APPLICATION FOR VARIATION OF CONDITION TO PLANNING APPLICATION NUMBER 2014/3303/P -GRANTED APPROVAL FOLLOWING APPEAL ON 14.11.2014

AS PROPOSED

glazed box which needed to be retracted to allow access to the roof. - Flat GRP roof. MS railings.
Painted black. Proposed Front Elevation

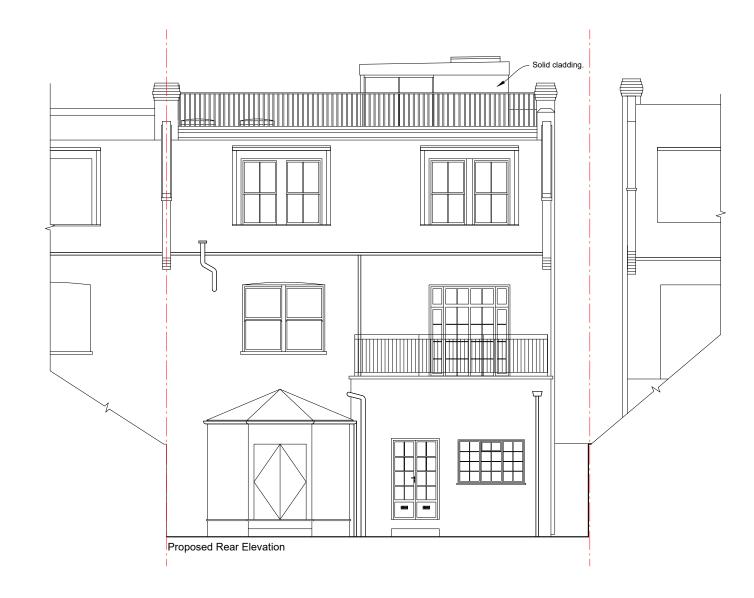
The proposed roof access lobby differs from the approved (under application 2014/3033/P) in that the roof access lobby is higher to allow standing access and longer to allow for an enclosed landing at the top of the stairs. The approved access was in the form of a sliding
